Re: Submittal of Revised Hydrogen Sulfide Prevention and Contingency Plan and  
Engineering Certification Report for the Evaporation Pond Liners  
Sundance Services West, Inc., Eunice, New Mexico

## Revised Hydrogen Sulfide Prevention and Contingency Plan

## Summary of Changes to the H<sub>2</sub>S Contingency Plan

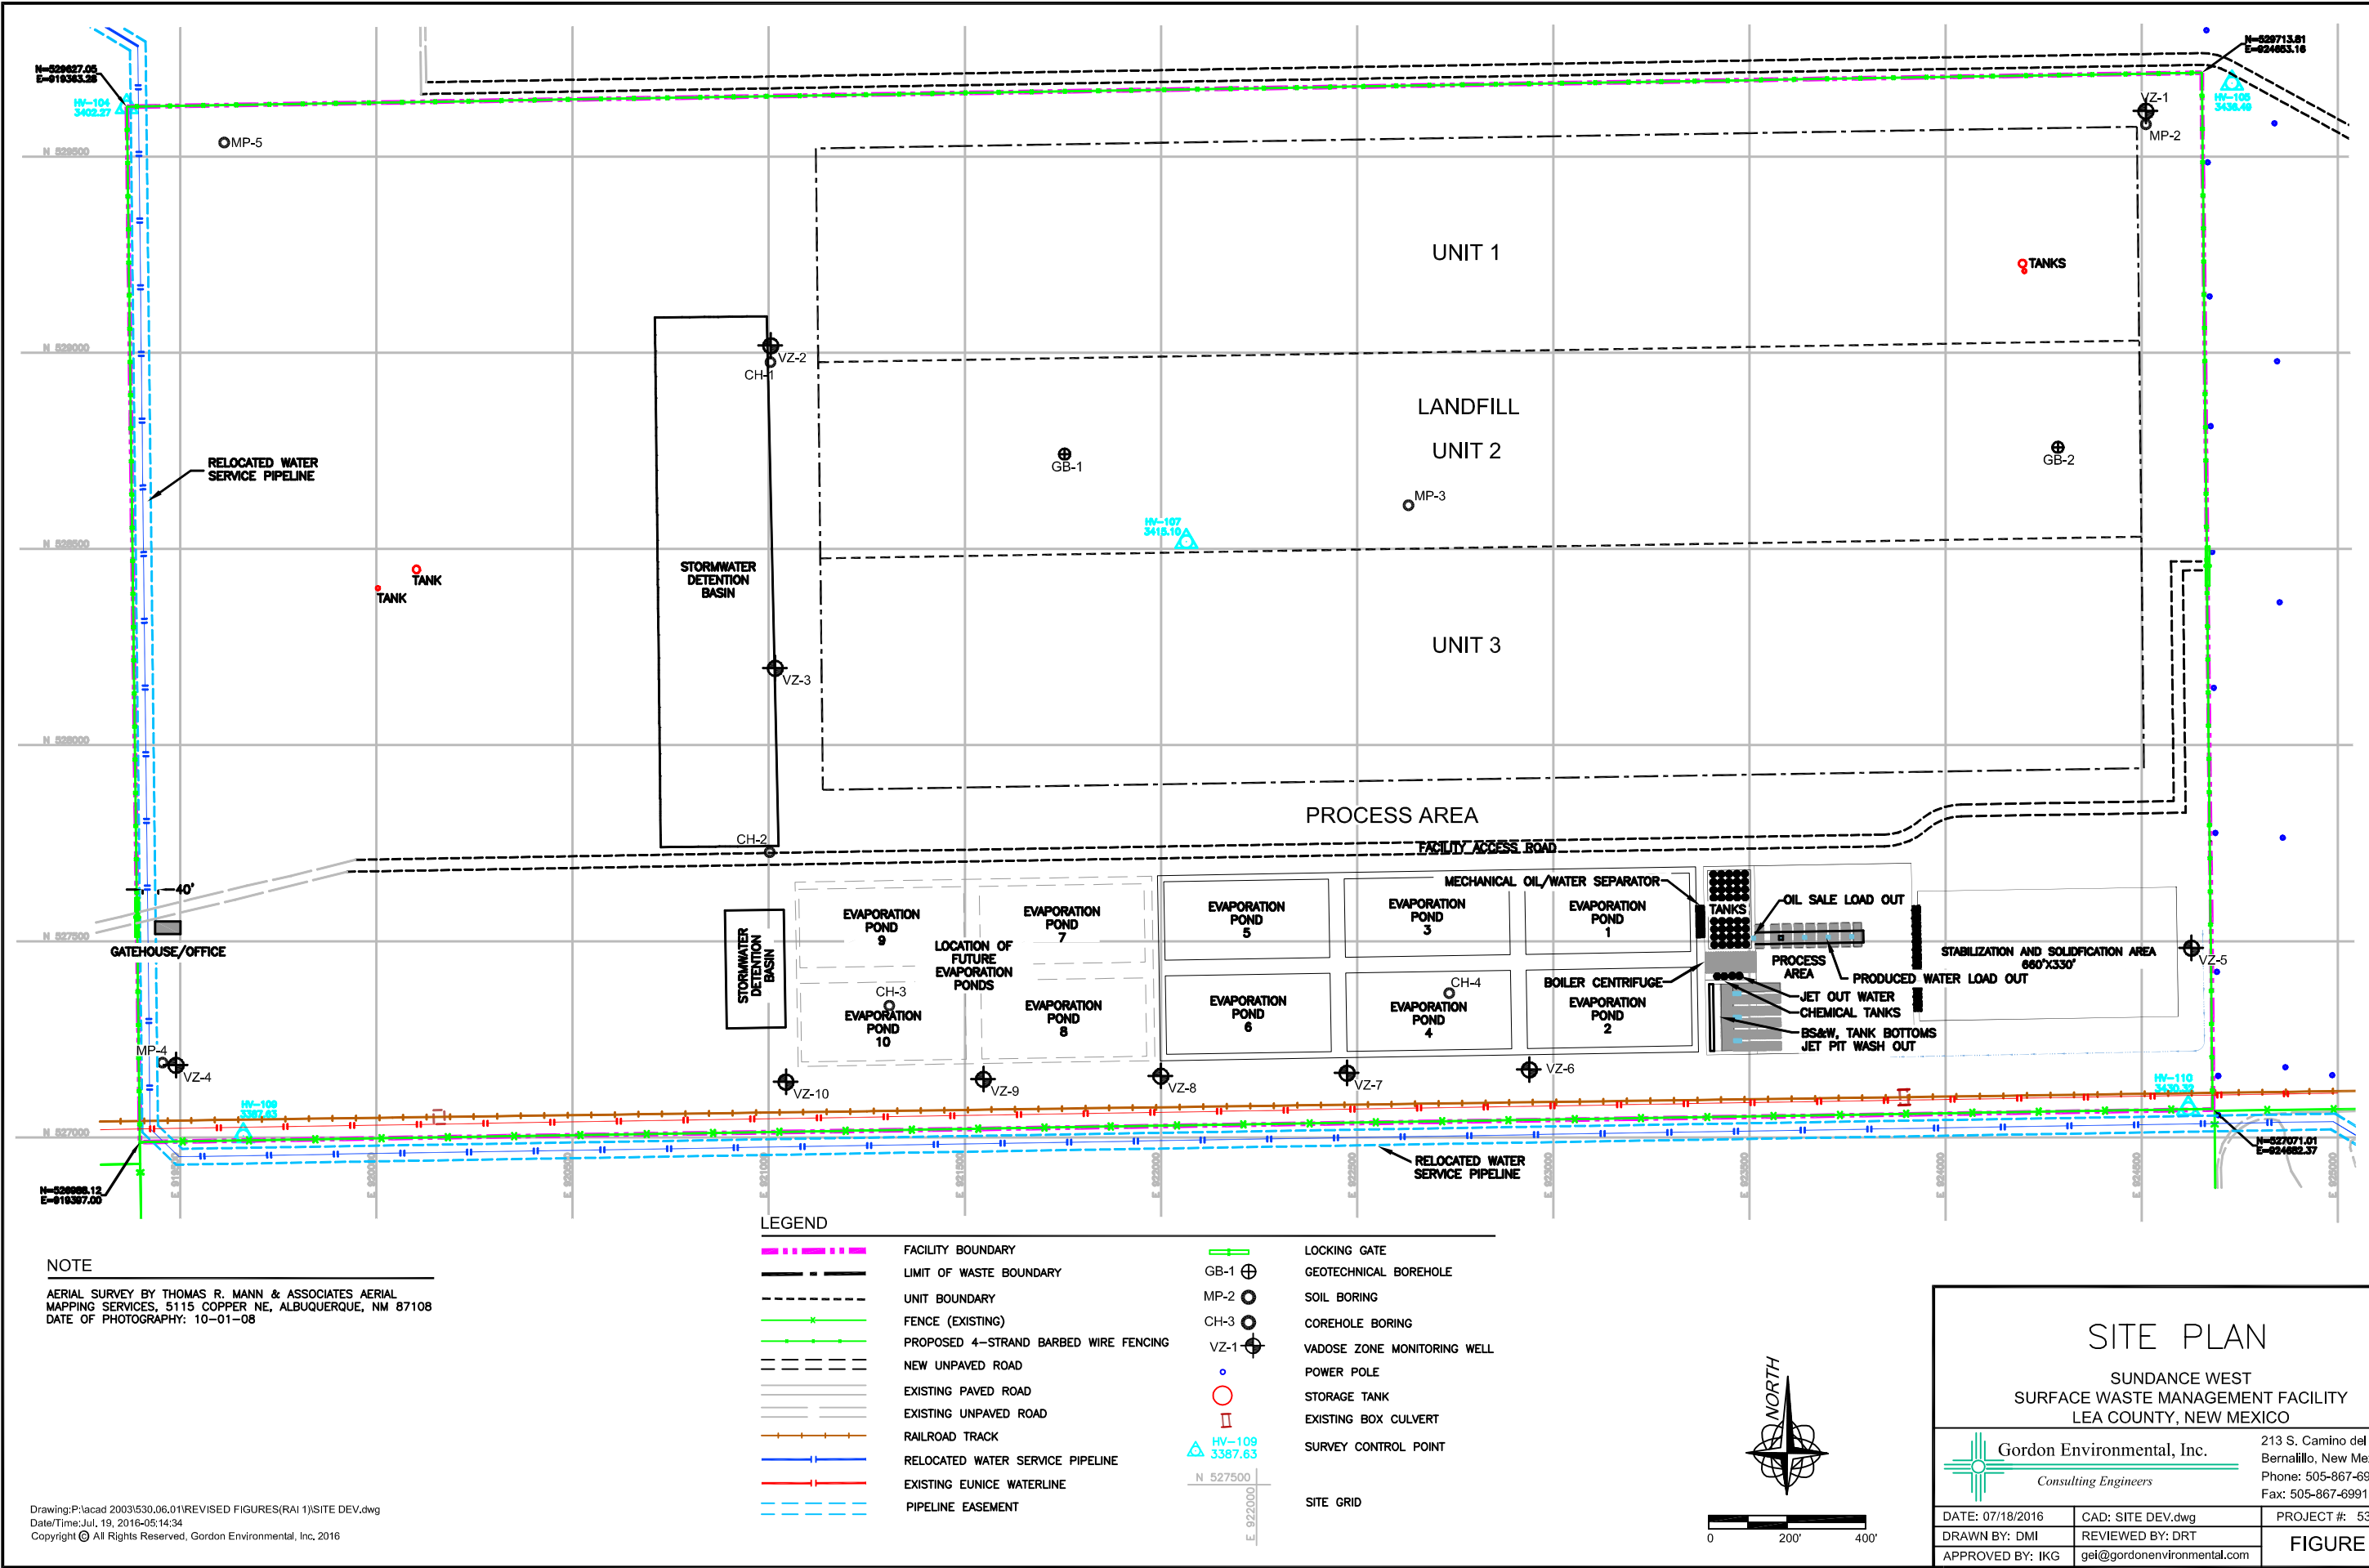
- OCD was unable to locate the radius of exposure (ROE) depicted on Figure II.3.2, as proposed in the last sentence of the second paragraph. Provide a reference to a different figure or update Figure II.3.2 accordingly and illustrate the ROE of 30 ppm. Also complete the assessment of public roads defined in 19.15.11.7.J NMAC, as required of 19.15.11.9.B(2)(a) NMAC.

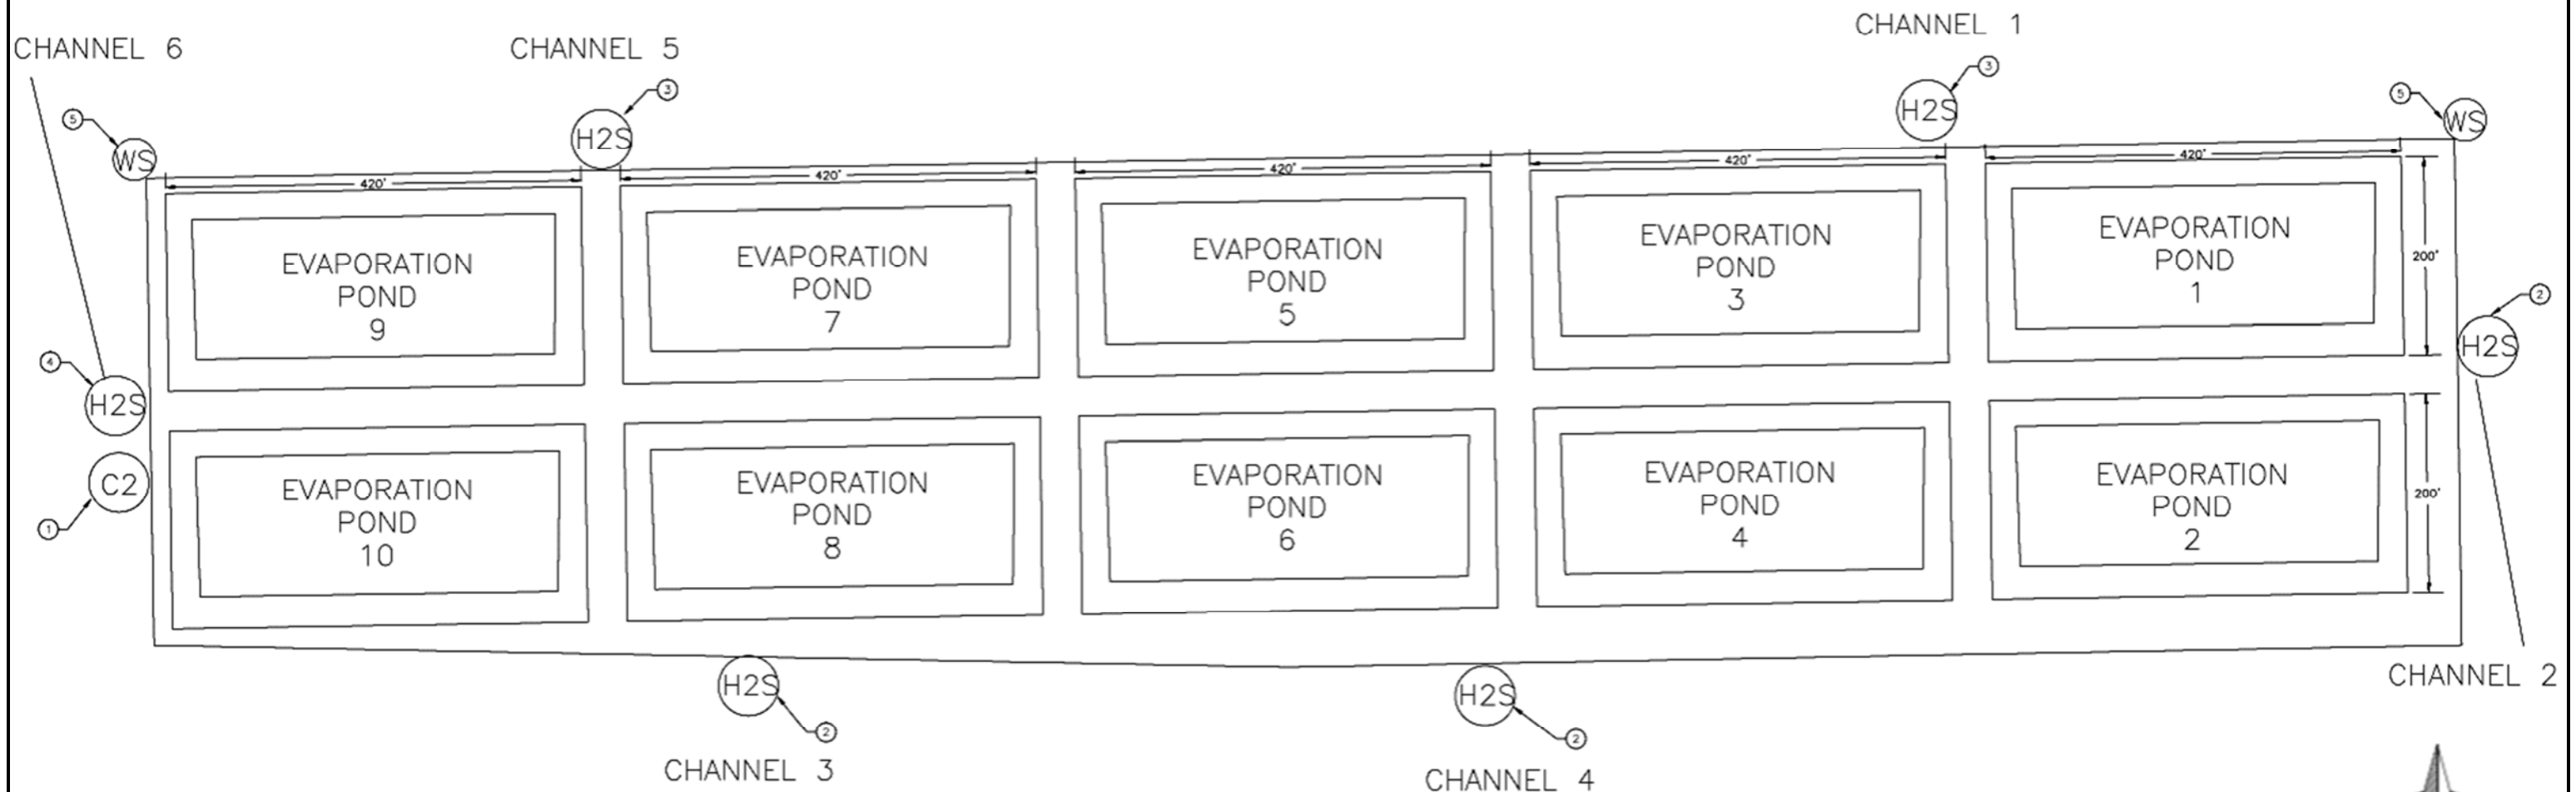
The current plan includes continuous monitoring around the perimeter of the evaporation ponds using 10 locations. This change reduces that number to 6 while still providing adequate monitoring around the perimeter of the ponds. Figure II.3.3 has been updated to reflect the new layout of the 6 monitors.

Evaporation ponds are monitored for the presence of H<sub>2</sub>S by recording at continuous monitors maintained along the outside perimeter of the pond area as shown on **Figure II.3.3**. These monitors can be observed remotely via the internet and measurements are recorded every 5 minutes on a data logging system. Wind socks are placed at the East and West ends of the Northern fence (shown in **Figure II.3.3**), which will be visible from all principle working areas at all times. Wind speeds and direction will also be monitored and recorded regularly when feasible.
